- FOR LEGENDS & SYMBOLS REF. V6Q0017									
CUSTOMER- TRIVENI TURBINE LIMITED W.O.NO. V5506C THIRD ANGLE PROJECTION SINGLE LINE DIAGRAM FOR 6.8KV RESERVE SUPPLY DISTRIBUTION SCHEME									
Crompton Greaves Ltd MV Switchgear Division Ambad, Nashik, India									
SCALE: NTS SHEET 1 OF 4 DATE: 24.08.13 REVISION: 01 ALL DIMENSIONS ARE IN mm DRG. NO. V6Q12983 REV 01

W.O.NO.V5506C

6.6kV HT SWITCHBOARD FOR RSSB

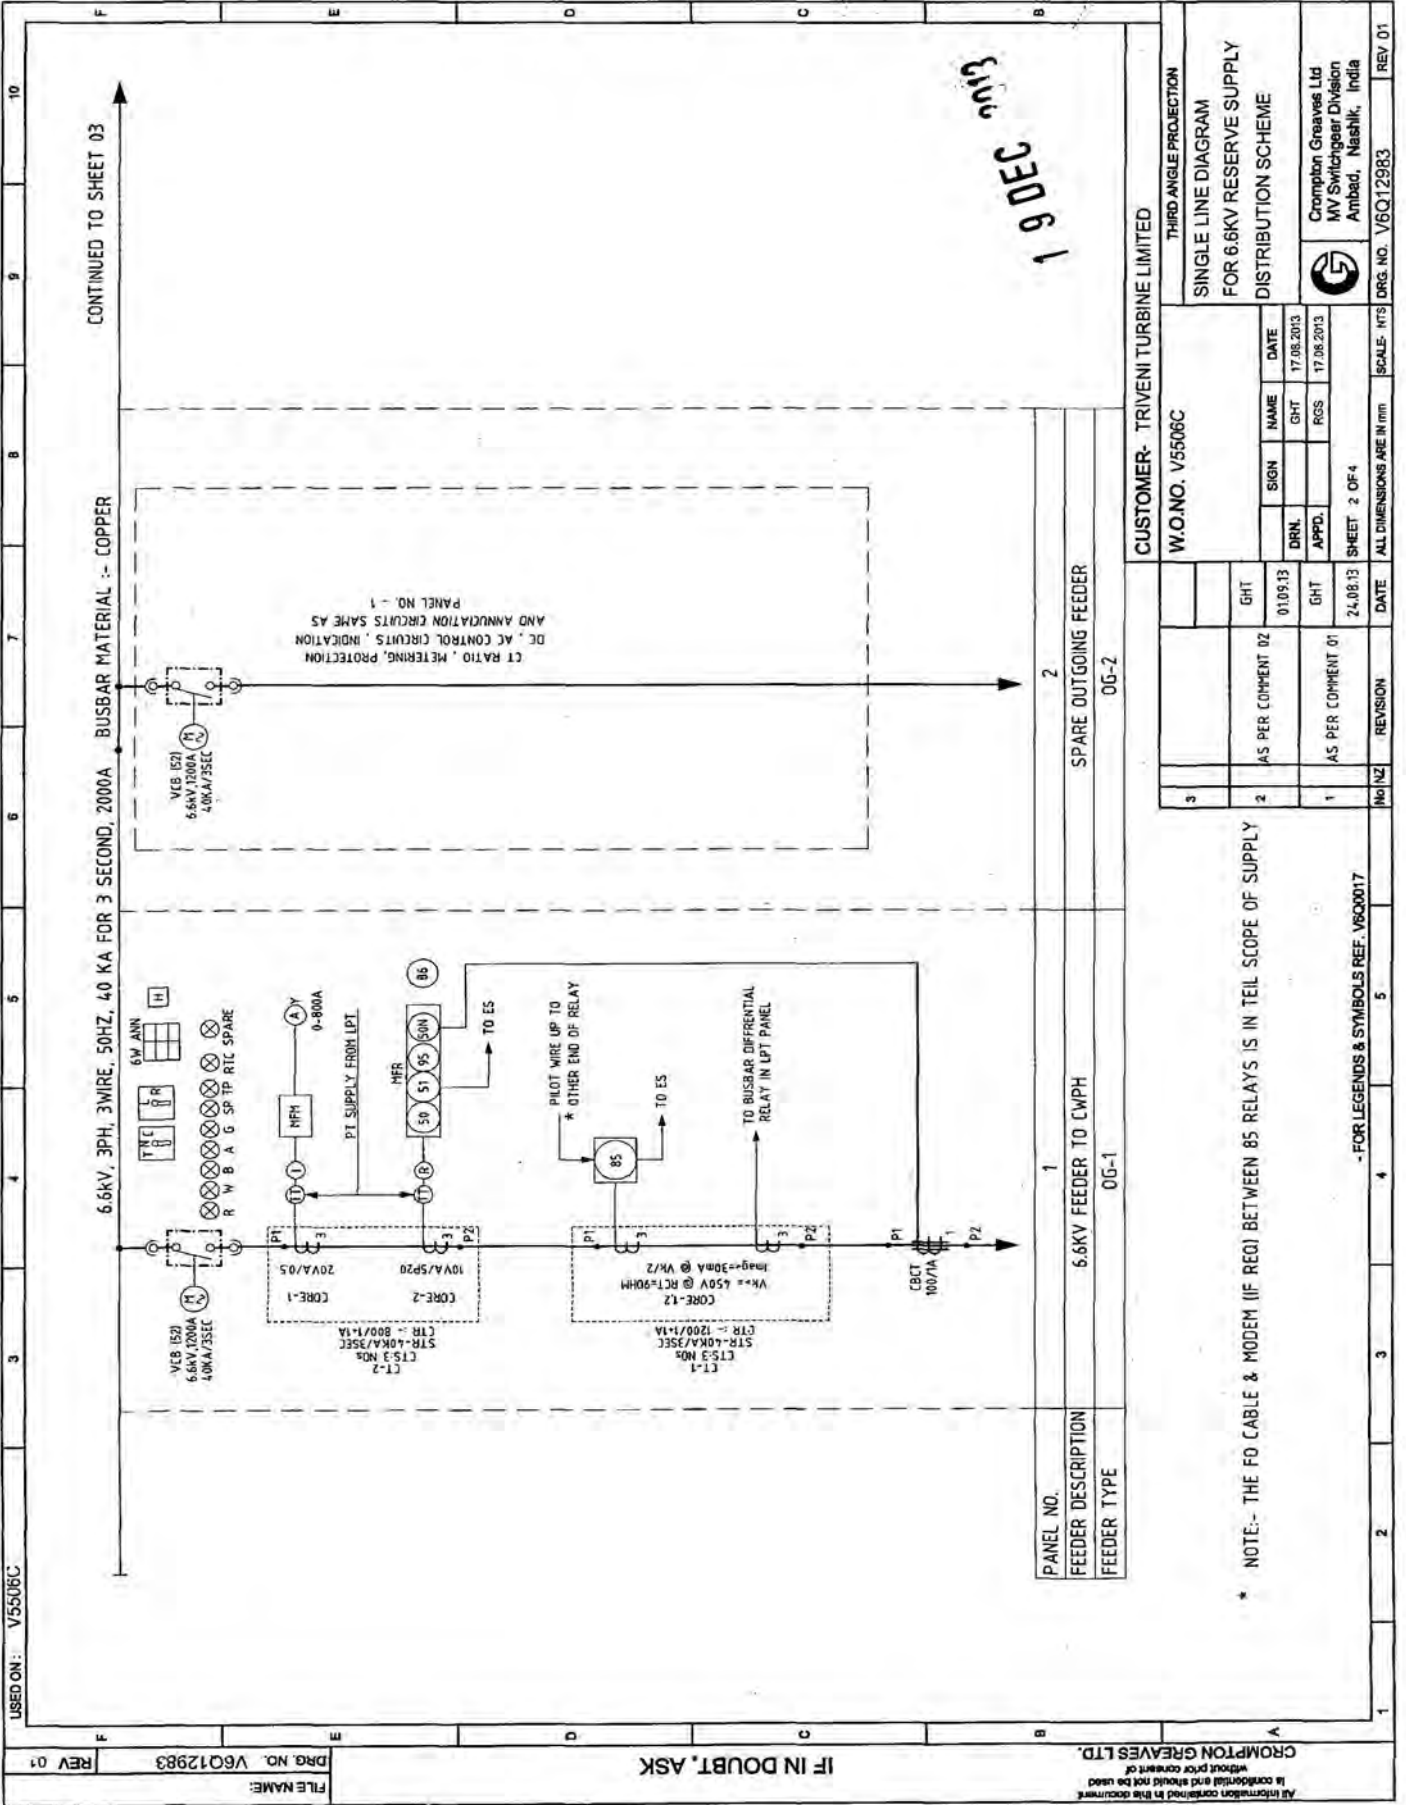
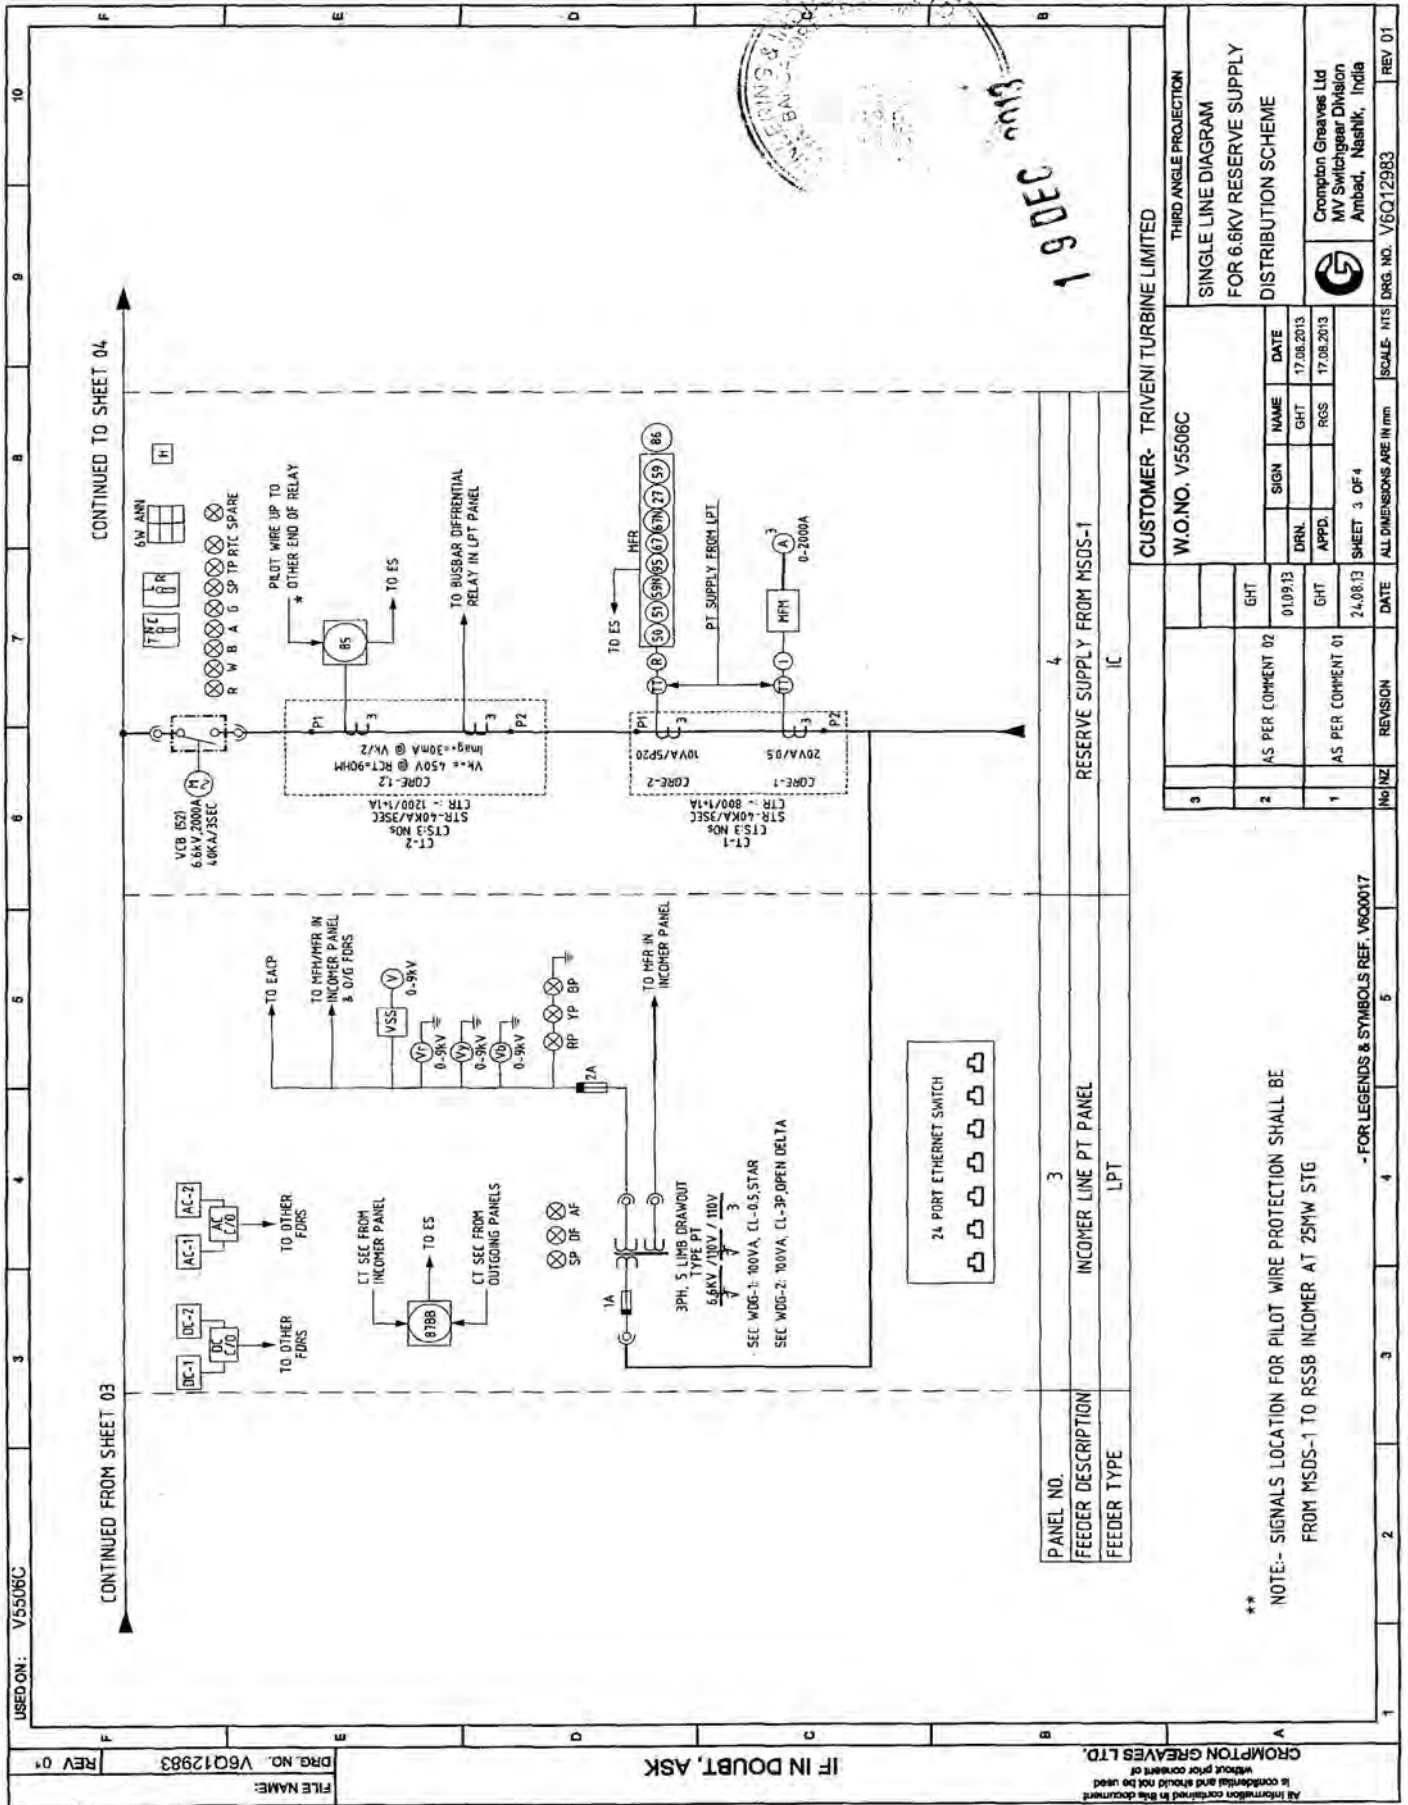
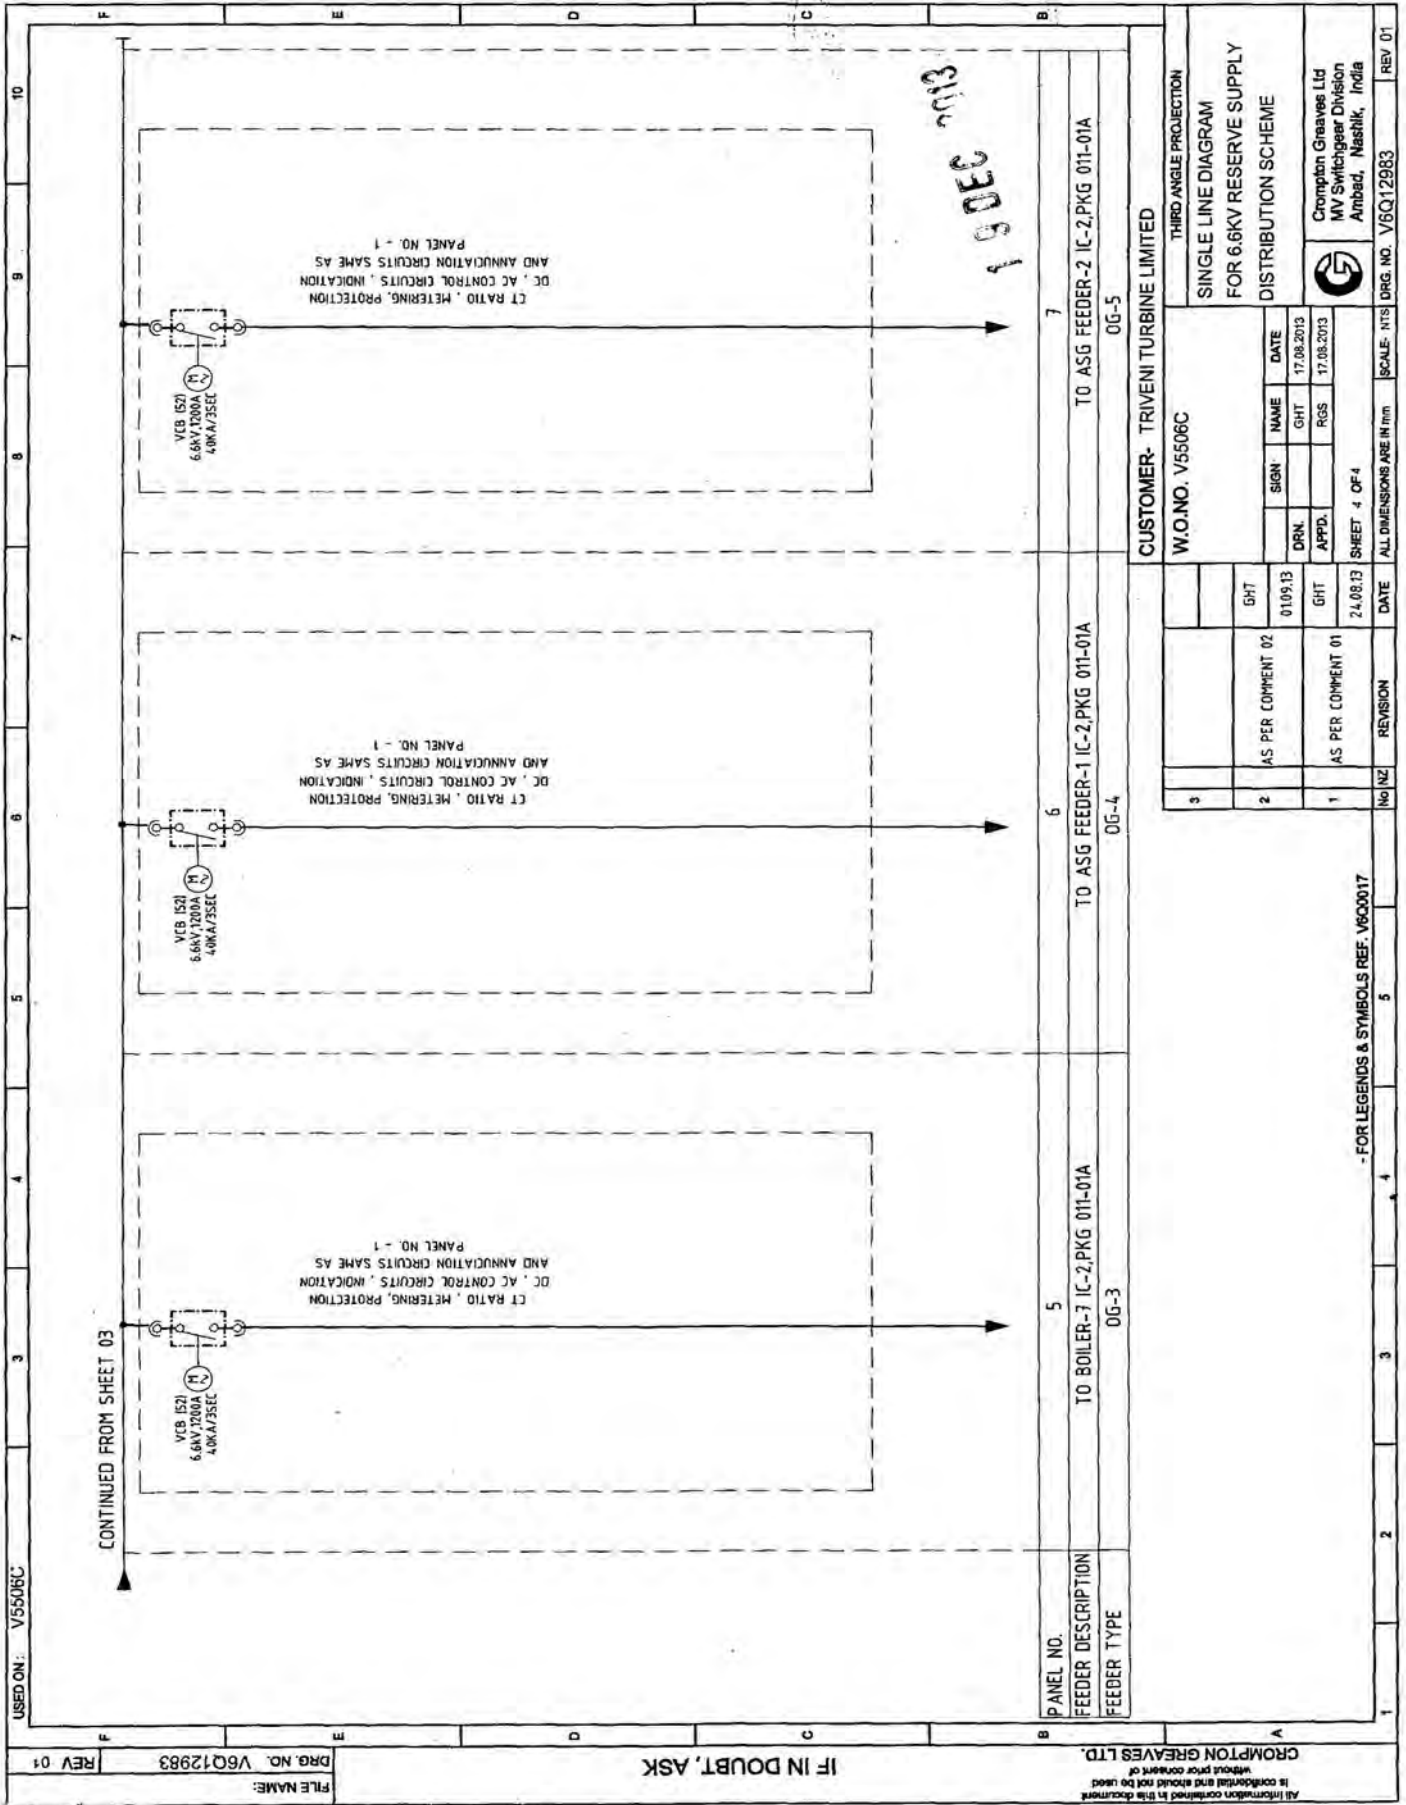
Sr.No.	Drg No.	Drg Description	Page No	25.09.13 BSP Comment 1	13.11.13 CGL Reply 1	Remarks
1	V6Q12983	SLD	2	Revised CTR to 800/1+1A. Add 87BB in LPT panel. CBCT ratio should be 100/1A	Complied	
2	V6Q12983	SLD	3	3No. 1-ph voltmeter shall be provided in LPT & general comments	Complied	
3	V4Q8421	GA	3	Remove Marshalling Panel	Complied	
4	V4Q8421	GA	5	Annunciator shall be dual supply AC/DC. R,Y,B ph indication is not required for I/C, O/G. Add 87BB relay, 3No. 1-ph voltmeter in LPT panel	Complied	
5	V6Q13121	Power circuit	1	general comment	Complied	
6	V6Q13121	Power circuit	2	additional CT core and 87BB relay	Complied	
7	V6Q13121	incomer	3_9	General Comments	Complied	
8	V6Q13123	LPT	2	Add 87BB in LPT panel	Complied	
9	V6Q13123	LPT	3	remove ACDC fail relay	Complied	
10	V6Q13125	Outgoing panel	1_9	General comments same as incomer	Noted
